National Park Service (NPS) Regional Haze SIP Supplement feedback for the Ohio Environmental Protection Agency (OEPA)

February 16, 2024

3.1 General James M. Gavin Power Plant

3.2 Cardinal Power Plant

Figure 1. Gavin, historic annual SO₂ emission rates (CAMPD 1997–2023)

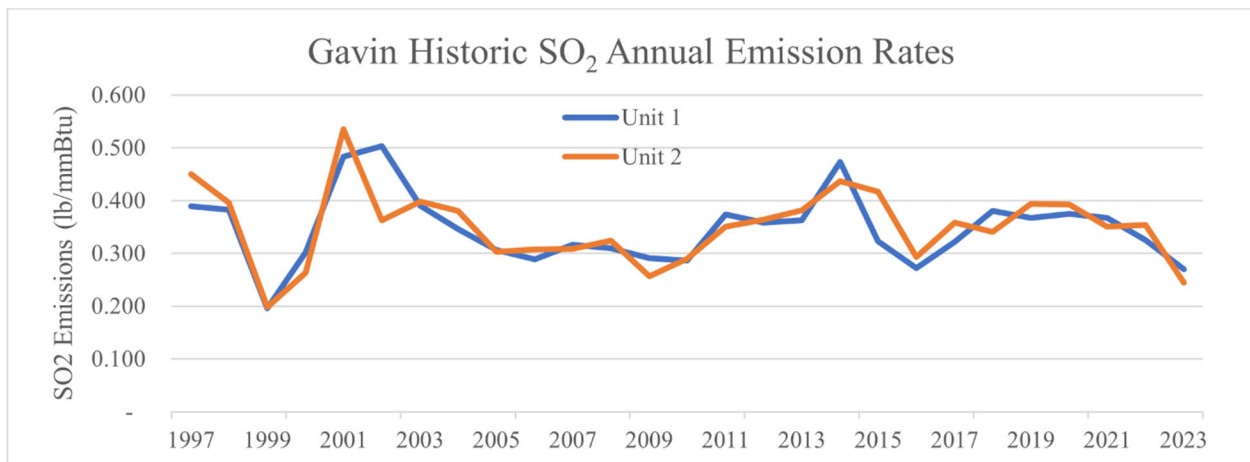
It appears that the recent scrubber upgrades cited by Gavin may have resulted in significant reductions in SO₂ emission rates during 2023 when SO₂ removal efficiencies approached 96%. However, Tables A-1 and A-2 in Appendix A.2 in Gavin’s Supplement indicate that scrubber efficiency could decline to 93.7%. Additionally, the W. H. Sammis, Cardinal, and Kyger Creek power plants are achieving higher SO₂ removal efficiencies while burning similar coals.

The NPS recommends that OEPA require an SO₂ emission limit of 0.075 lb/MMBtu annual average (99% control) which could be achieved by replacement of the 30-year-old WFGDs at Gavin with new WFGDs. Scrubber replacement could reduce SO₂ emissions from the facility by over 24,000 tons/year for an estimated \$5,900–\$7,100/ton (in 2022\$). This is well within the range of cost-effectiveness thresholds used by other states for regional haze in the second implementation period and is OEPA’s single biggest opportunity to reduce haze causing emissions in this planning period.

Figure 2. Gavin, historic annual NO_x emission rates (CAMPD 1997–2023)

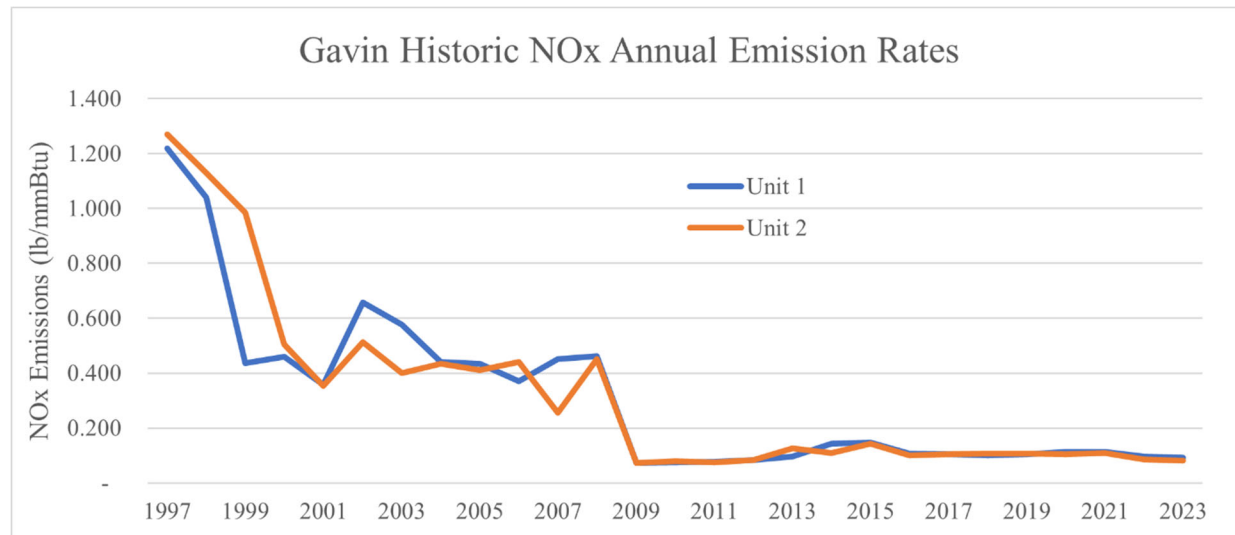
SCRs were installed May 1, 2001, on Unit 1 & Unit 2. Beginning in 2009, emissions were reduced to about 0.1 lb/MMBtu and the SCR systems appear to be achieving 76-81% control.¹⁵

The American Electric Power (AEP) Consent Decree stipulated that, “No later than the dates set forth in the table below, Defendants shall install and Continuously Operate SCR on each Unit identified therein, or, if indicated in the table, Retire, Retrofit, or Re-power such Unit.” The applicable compliance date for the two Gavin units was January 1, 2009. The effect of the SCRs can be seen in the chart above.

The SCR systems¹⁶ at Gavin were installed in 2001 prior to the first implementation period and do not appear to be achieving 90% control. Both criteria suggest that a four-factor analysis is warranted under the 2019 EPA regional haze guidance. In addition, the SCR systems for both Gavin units performed significantly better from 2009–2012 and during the most-recent two years (2022 & 2023).

The NPS recommends that OEPA implement a 30-day rolling average NO_x limit of 0.10 lb/MMBtu for Gavin EGUs to ensure that the SCRs are “*continuously operated so as to minimize emissions to the greatest extent possible in accordance with the requirements of the AEP Consent Decree and federally-enforceable Title V permit.*” In addition, optimization of the 20-year-old SCR systems is likely very cost-effective. Optimization could likely achieve an annual emission limit of 0.08 lb/MMBtu reducing NO_x emissions by 1,700 tons/year.

Figure 3. 2009-2023 ozone season NO_x emission rates for Gavin Units 1 & 2 (CAMPD 2023)

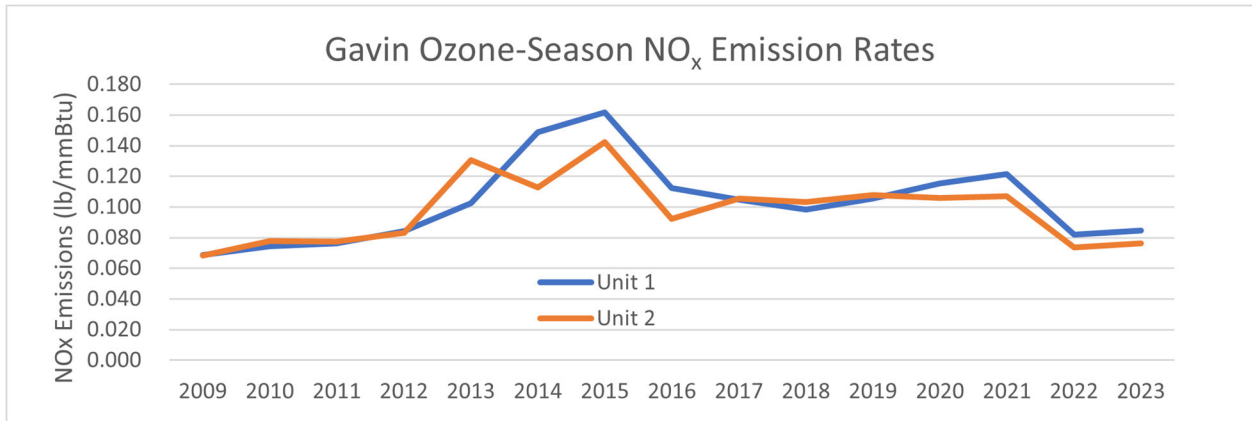
It appears that the Gavin SCR systems may not be “continuously operated so as to minimize emissions to the greatest extent possible in accordance with the requirements of the AEP Consent Decree and federally-enforceable Title V permit,” as there are periods of much better SCR performance than others.

Figure 5. 2010–2023 Annual SO₂ emission rates for Cardinal Units 1 & 2 and 2013–2023 Annual SO₂ emission rates for Cardinal Unit 3 (CAMPD 2023)

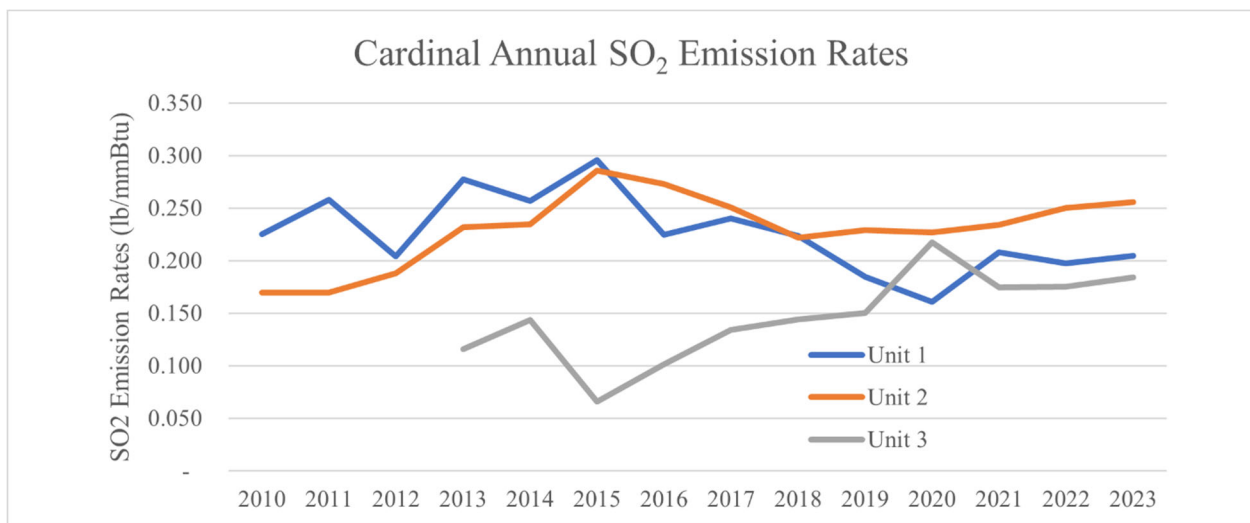
However, as shown in Figure 5, each of the Cardinal Units has achieved higher levels of SO₂ removal efficiency in the past than they are currently achieving, indicating that a scrubber optimization analysis is warranted for all three units. Cardinal Unit 1 SO₂ emission rates have increased from 0.163 lb/mmBtu in 2020. Cardinal Unit 2 SO₂ emission rates have increased from a low of 0.170 lb/mmBtu in 2011 and are now higher than either of the other units. Cardinal Unit 3 performed most efficiently in 2015 when it achieved an SO₂ emission rate of 0.066 lb/mmBtu.

Based on recent SO₂ WFGD performance at Cardinal, the NPS concludes that an SO₂ scrubber optimization analysis is warranted for all three emission units. Optimization to the levels of efficiency previously attained for each of the Cardinal units could reduce a combined 3,500 tons of SO₂ emissions annually, in comparison to 2019–2023 average emissions.

- Unit 1 potential SO₂ reductions (461 tons/year) are based on 0.163 lb/mmBtu.
- Unit 2 potential SO₂ reductions (1,219 tons/year) are based on 0.170 lb/mmBtu.
- Unit 3 potential SO₂ reductions (1,885 tons/year) are based on 0.066 lb/mmBtu.

Figure 6. 2009–2023 Annual NO_x emission rates for Cardinal Units 1–3, CAMPD 2023

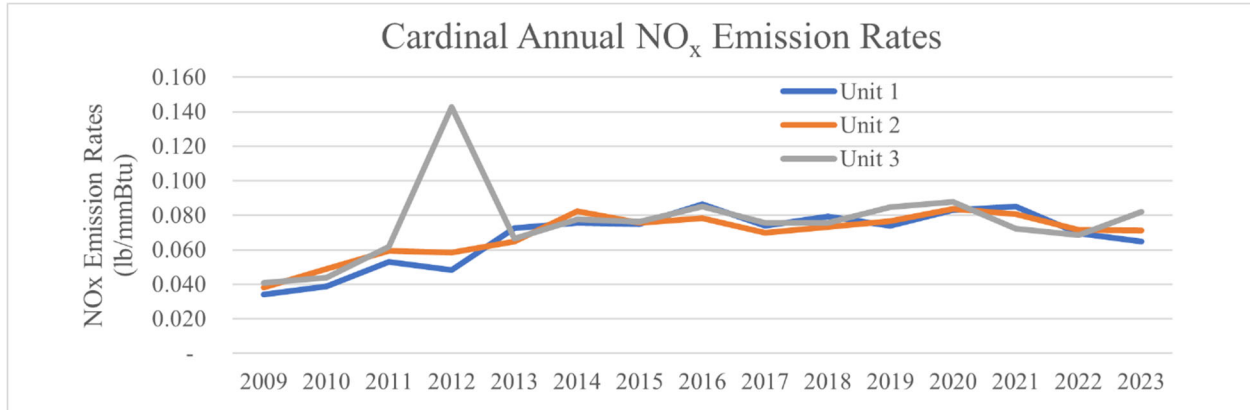
The current SIP Supplement does not address NO_x emissions controls for Cardinal. However, NPS review of recent data finds that Cardinal Units 1, 2, and 3 are not effectively controlled for NO_x emissions. In fact, recent data show increasing NO_x emissions from all three units.

The EPA’s 2021 Clarification Memo recommends analysis of lower emission rate(s) previously achieved as a potential control option for reasonable progress.

The NPS recommends that OEPA require a four-factor analysis of SCR optimization for these units and implementation of reasonable cost-effective control improvements identified through the analysis. Optimization of the 20-year-old SCR systems is likely very cost-effective and could achieve an emission limit of 0.04 lb/MMBtu for Cardinal. Implementation of this rate could reduce annual NO_x emissions from the Cardinal facility by over 1,800 tons.
